SERVICE TIPS

82-16

GAME: POWER SUPPLY #08-00007-001 USED ON "QIX", ALPINE SKI, WILD WESTERN,
KRAM, ELECTRIC YO YO.

SUBJECT: BR1 AND BR2 HEATING UP TO THE EXTENT OF BREAKING DOWN INTERNALLY.

FIGURE 1

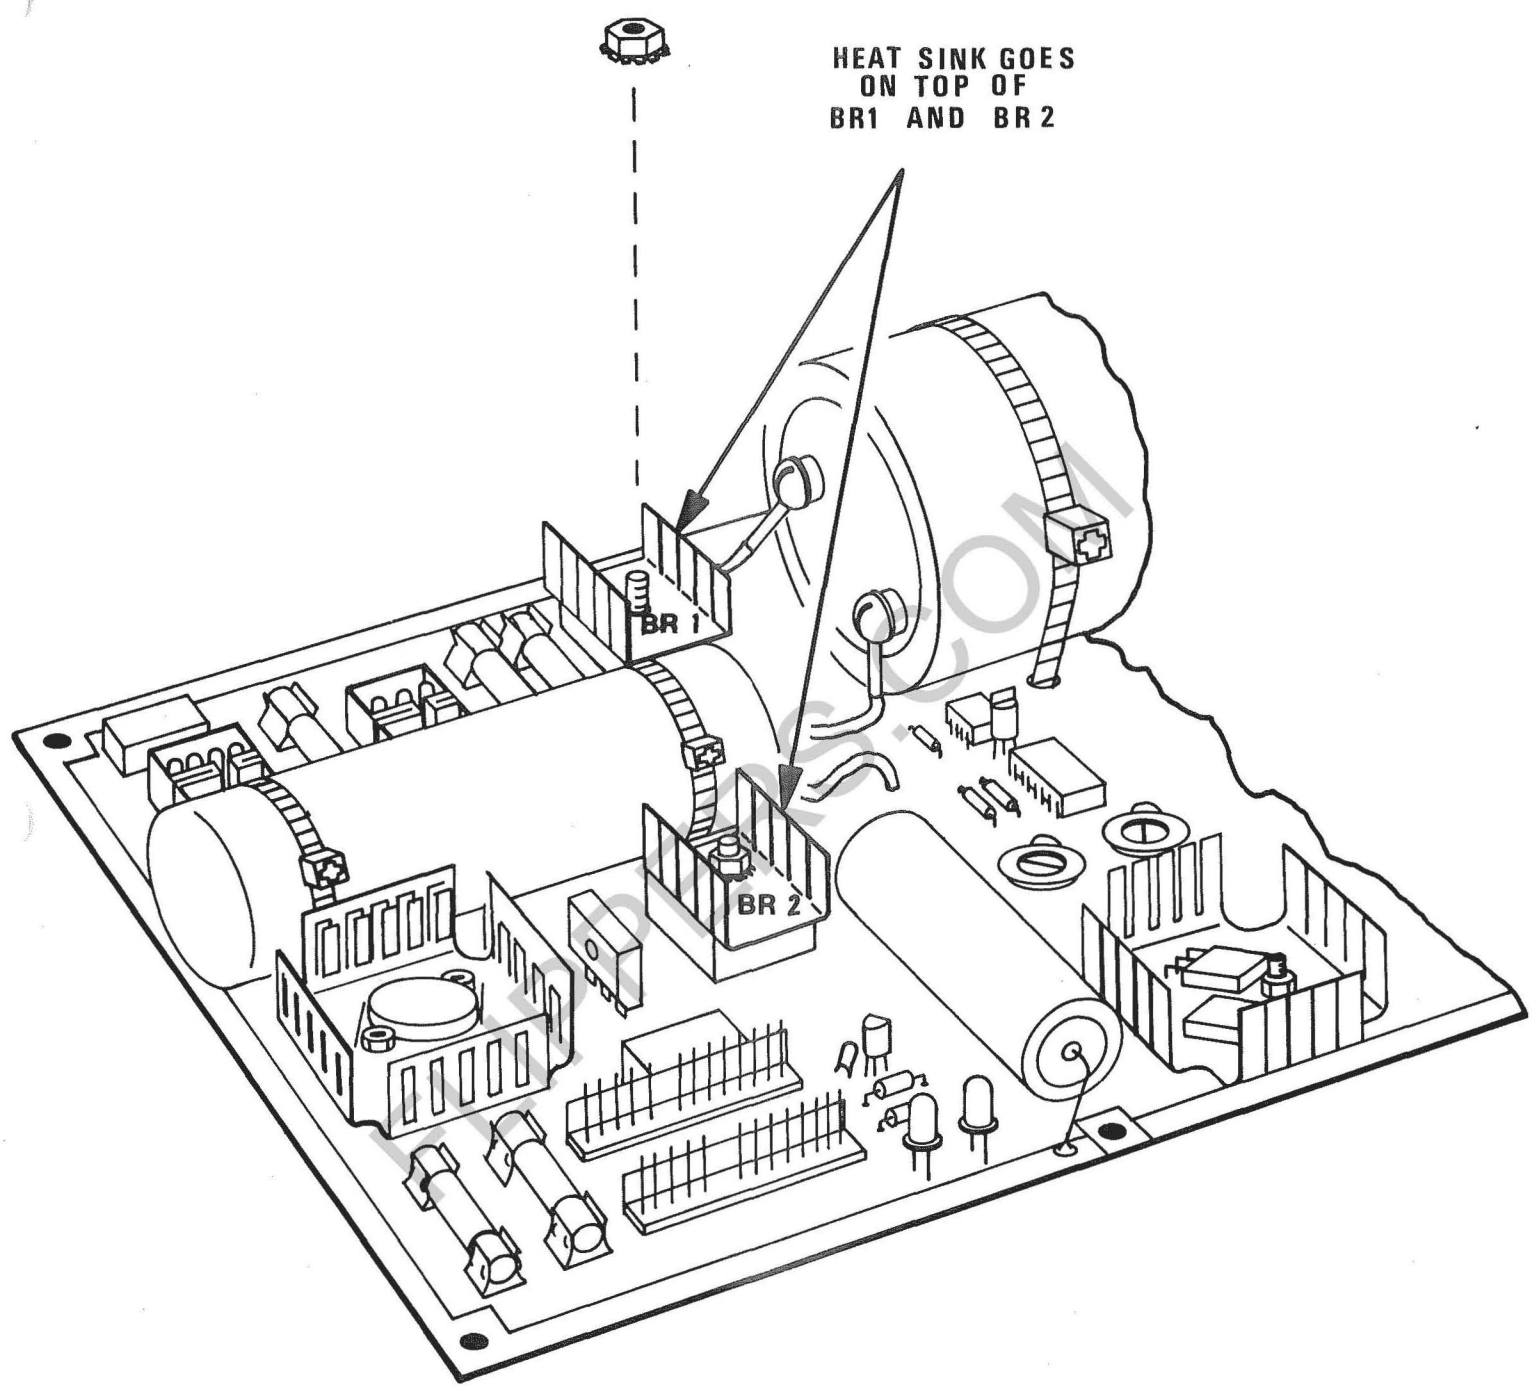
SOLUTION: ADDING HEAT SINKS ONTO BR1 AND BR2.

PROCEDURE: POWER DOWN GAME, REMOVE POWER SUPPLY P.C.B. 08-00007-001
APPLY HEAT SINK COMPOUND TO THE TOP OF BR1 AND BR2 (REFER
TO FIGURE 1). PLACE A HEAT SINK ON TOP OF BR1 ALIGNING HOLES
AND MAKING SURE THAT HEAT SINK DOESN'T TOUCH ANY OTHER
COMPONENTS. FEED THE SCREW THROUGH THE ETCH SIDE OF THE
POWER SUPPLY. TIGHTEN THE NUT SNUGGLY. REPEAT PROCEDURE
FOR BR2.

HEAT SINK GOES
ON TOP OF
BR1 AND BR 2

FIGURE 1

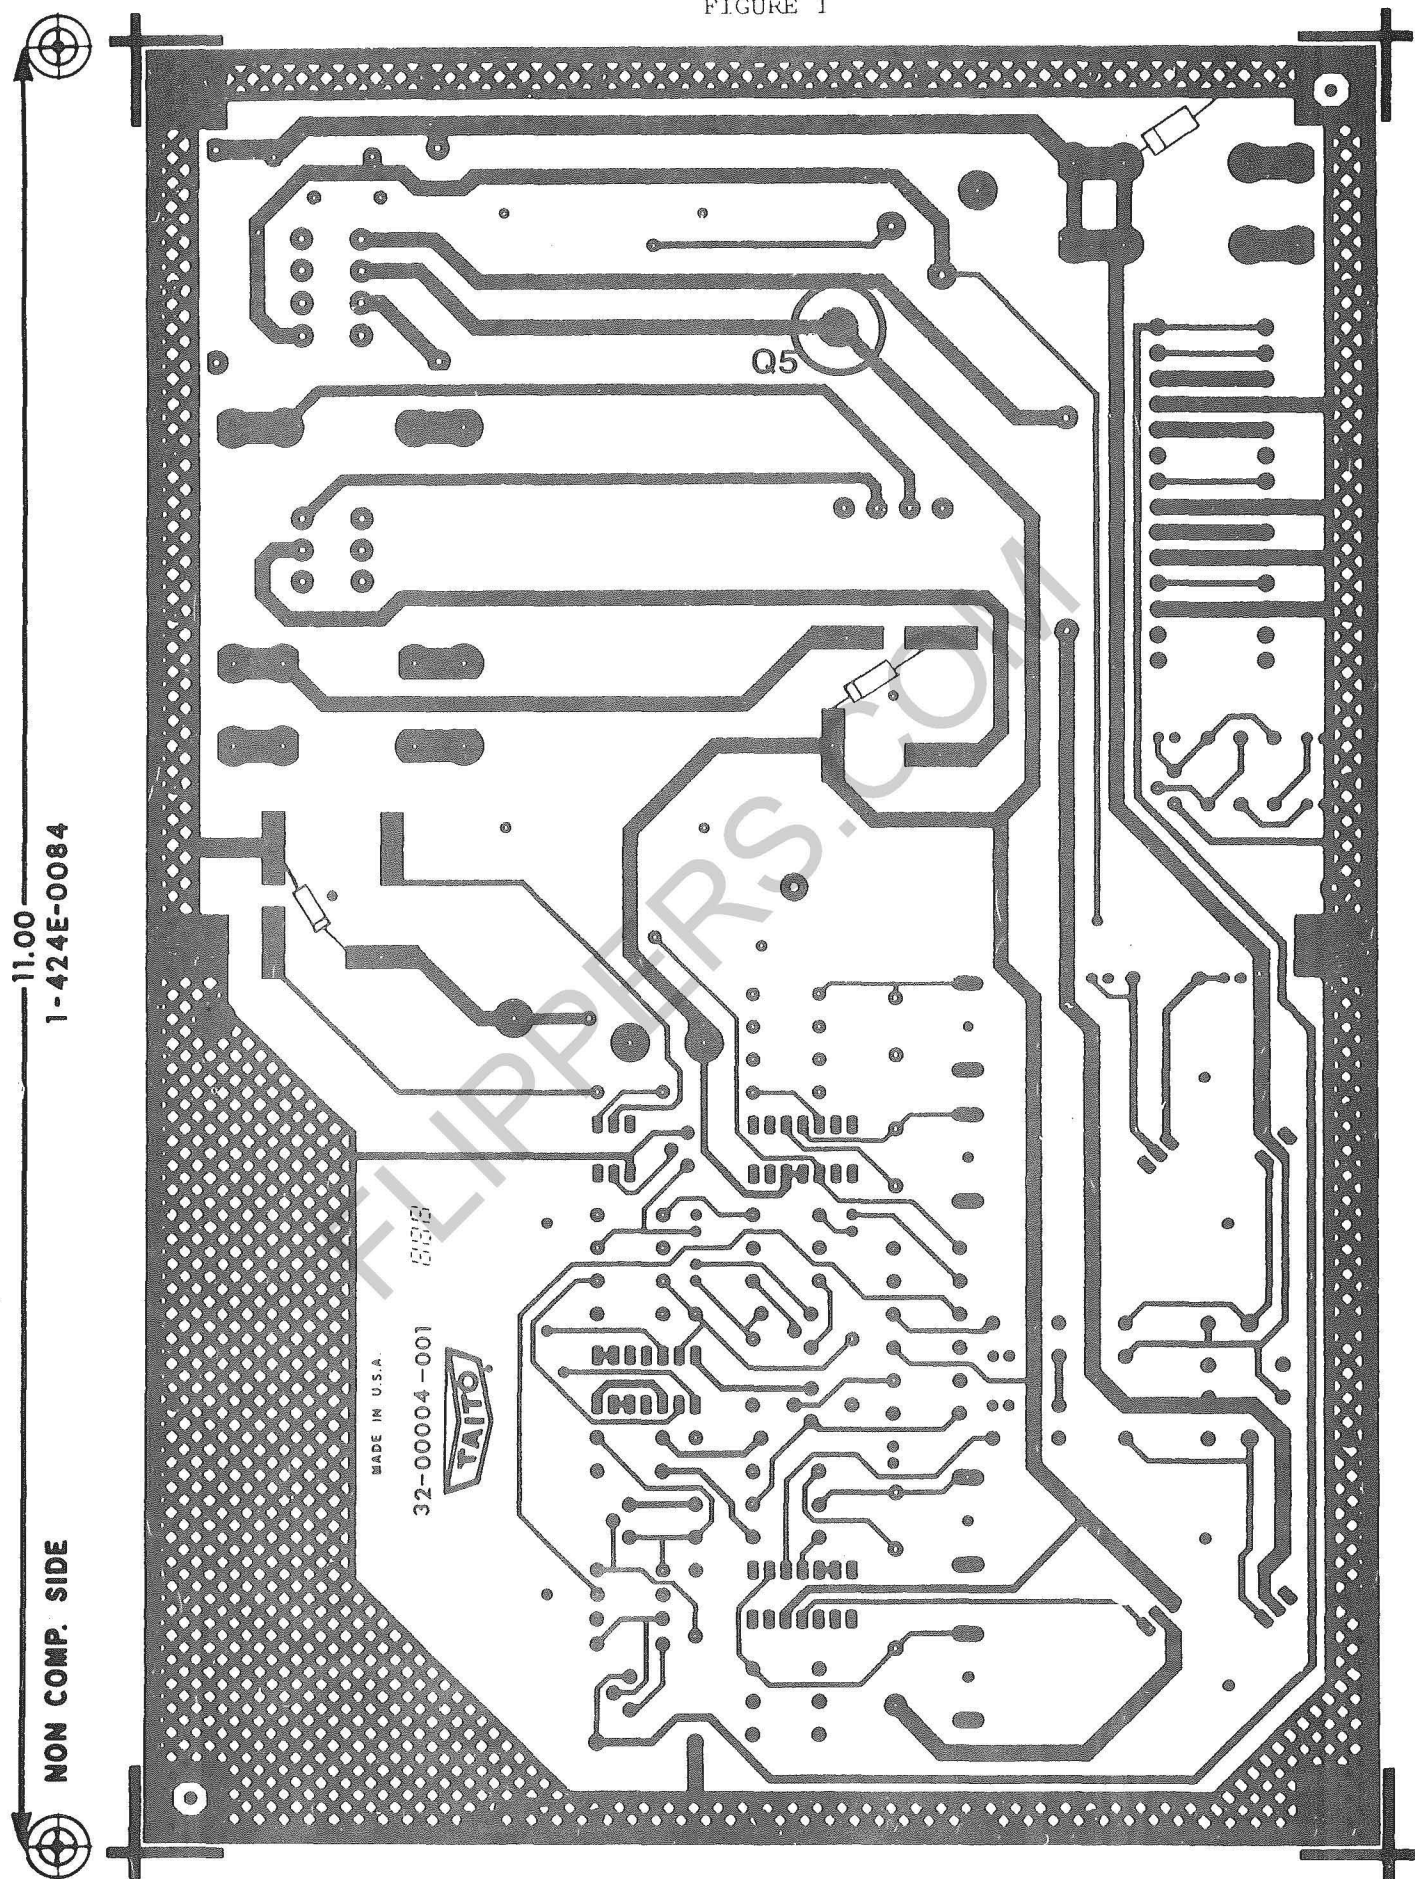
SUBJECT: POWER SUPPLY +5 VOLT PROBLEMS

SOLUTION: IMPROVE Q5'S CONNECTION ON POWER SUPPLY

PROCEDURE: REMOVE THE TWO NUTS AND BOLTS HOLDING DOWN Q5. ON THE ETCH
SIDE OF THE BOARD (REFER TO FIGURE 1), SCRAPE THE GREEN SOLDER
RESIST OVER THE FOIL AROUND THE SCREW PAD FOR Q5. WET THE
PAD WITH SOLDER TO MAKE SURE THAT ALL SOLDER RESIST MATERIAL
IS REMOVED. REPLACE NUTS AND BOLTS FOR Q5.

FIGURE 1

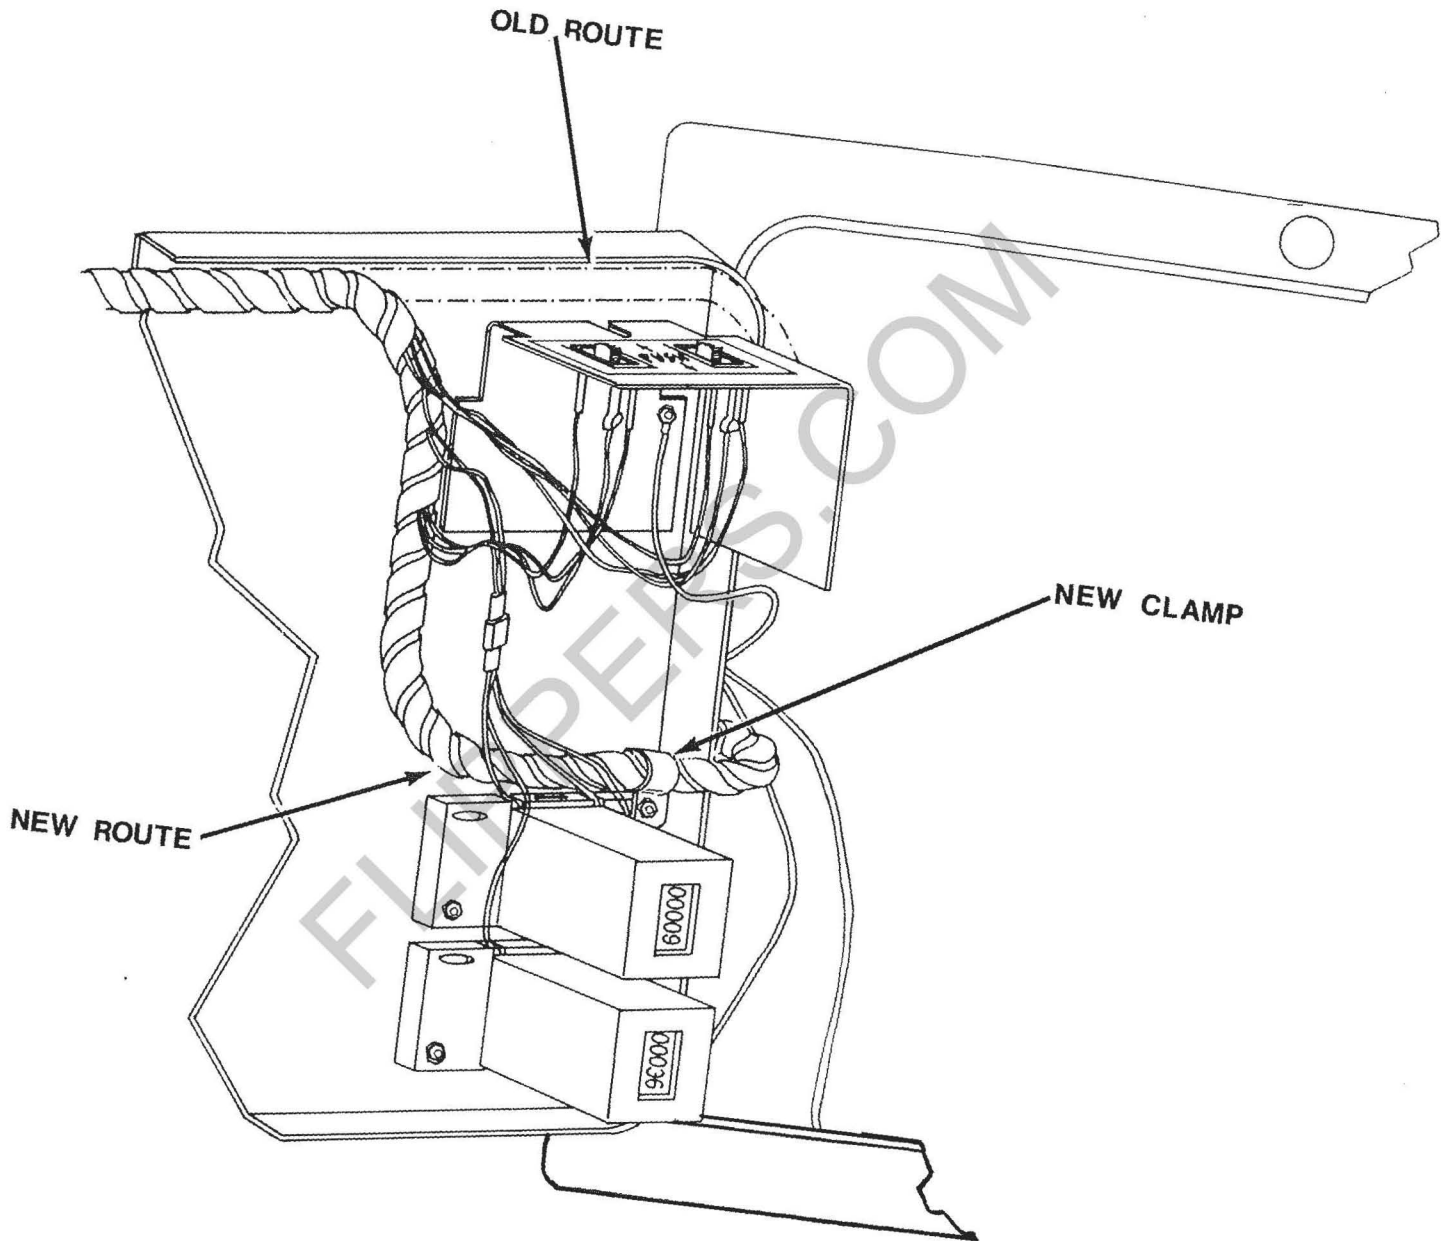
SUBJECT: COIN DOOR CABLE CAN GET PINCHED IN COIN DOOR FRAME.

SOLUTION: RE-ROUTING OF COIN DOOR CABLING AND ITS HARNESS AS FOLLOWS:

- PROCEDURE:
1. RE-ROUTE COIN DOOR HARNESS AS FOLLOWS:
 - A. UNLOCK AND OPEN COIN DOOR.
 - B. UNLATCH AND REMOVE GAME CONTROL PANEL.
 - C. REMOVE SECOND CABLE CLAMP ON THE LEFT OF THE HARNESS THAT RUNS ABOVE THE COIN DOOR.
 - D. IF THERE ARE ANY EXTRA LOOSE WIRES ON THE HARNESS NOW FREE, USE 4" TIE-WRAP (59-00003-001) TO BIND THEM TO THE HARNESS.
 - E. UNPLUG MOLDED CONNECTOR TO COIN DOOR.
 - F. REMOVE CABLE CLAMP HOLDING POWER INTERLOCK WIRING, AND REINSTALL AROUND THE HARNESS THAT IS NOW FREE.
 2. RE-ROUTE CABLE ON COIN DOOR AS FOLLOWS: (SEE FIG. 1)
 - A. SNIP WIRE TIE THAT HOLDS FLEXIBLE CABLE TO COIN DOOR (ABOVE SERVICE SWITCH BRACKET).

- B. RE-ROUTE CABLE TO THE LEFT OF AND UNDER THE SERVICE SWITCH BRACKET.
 - C. REMOVE UPPER RIGHT NUT FROM THE TOP COIN COUNTER.
 - D. REINSTALL NUT TRAPPING SMALL CABLE CLAMP (59-00004-004) AROUND COIN DOOR CABLE ON COIN COUNTER SO THE CABLE IS NOW POSITIONED HALF-WAY DOWN THE COIN DOOR HINGE.
3. REINSTALL CABLES AS FOLLOWS: (SEE FIG. 2)
- A. REMOVE LOWER RIGHT SCREW ON INTERLOCK ASSEMBLY COVER.
 - B. REINSTALL SCREW, ANCHORING PREVIOUSLY REMOVED CABLE CLAMP AROUND COIN DOOR CABLE.
 - C. RECONNECT MOLDED CONNENCTORS FOR COIN DOOR CABLE.
 - D. VERIFY THAT CABLE FREELY MOVES THROUGH CABLE CLAMP UNDER INTERLOCK ASSEMBLY COVER, TO PREVENT PINCHING THE CABLE.

FIGURE 1

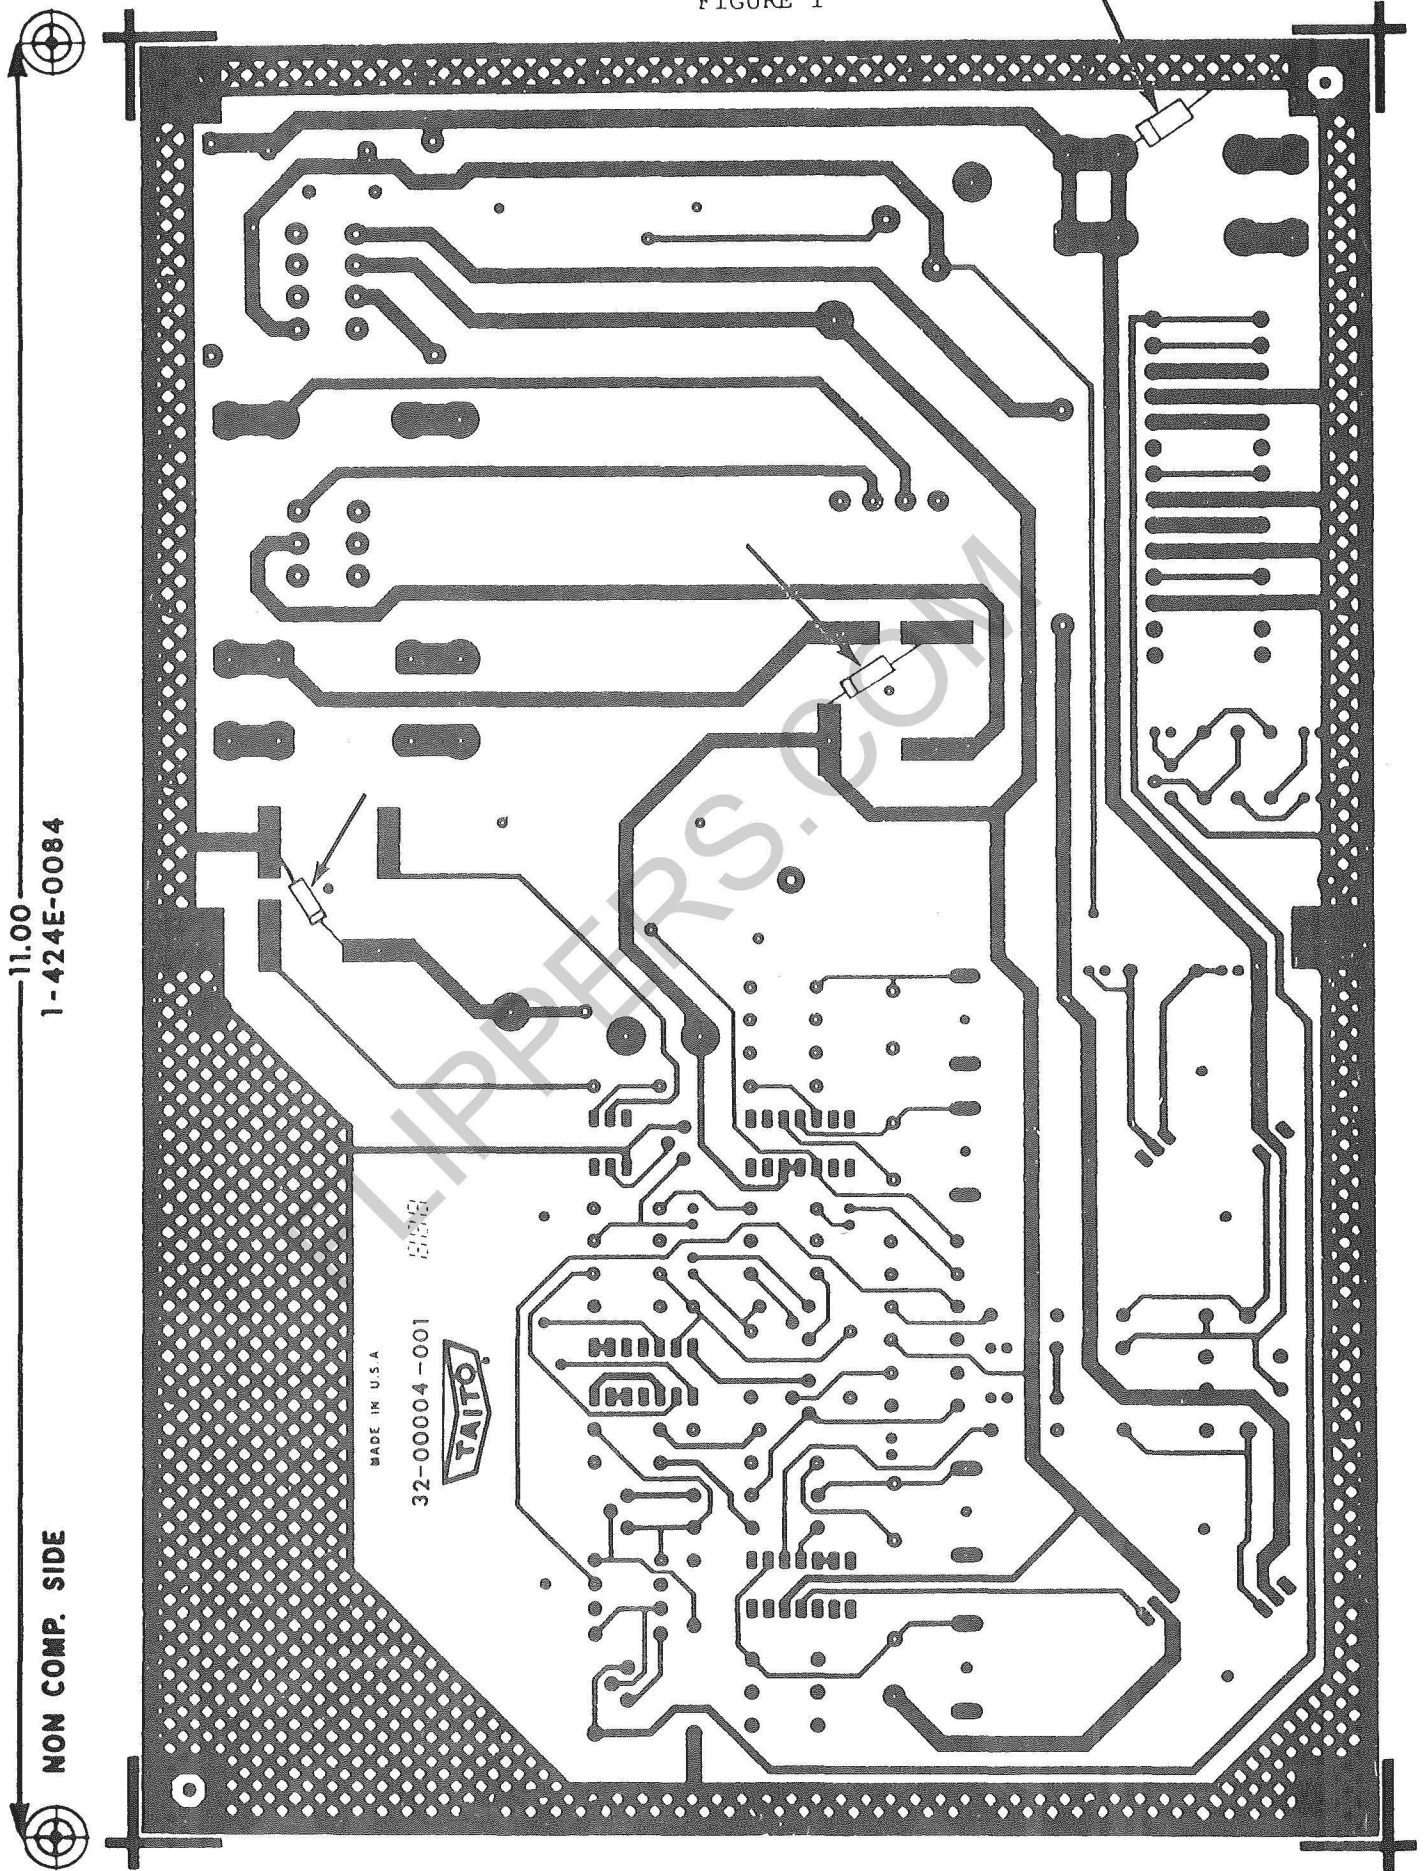
THERE ARE COMPONENTS UNDER THE POWER SUPPLY THAT LOOK LIKE DIODES (REFER TO FIGURE 1 AND 2)(ON ISS. "C" OF THE POWER SUPPLY THEY ARE CALLED D13, D14, D17 AND ARE ON THE COMPONENT SIDE). THESE COMPONENTS ARE CALLED TRANSORBS. THEY ARE USED TO COMPENSATE FOR FLUCTUATING A.C. LINE VOLTAGES. MEASURING THEM OUT OF CIRCUIT, OTHER THAN CHECKING FOR SHORTS, IS USELESS. THE ONLY WAY TO TEST THEM IS TO TAKE THEM OUT OF CIRCUIT, AND THEN POWER UP THE POWER SUPPLY WITH A LOAD. IF THE VOLTAGE, AFTER ADJUSTMENT, IS CORRECT, THEN THE TRANSORB NEEDS TO BE REPLACED.
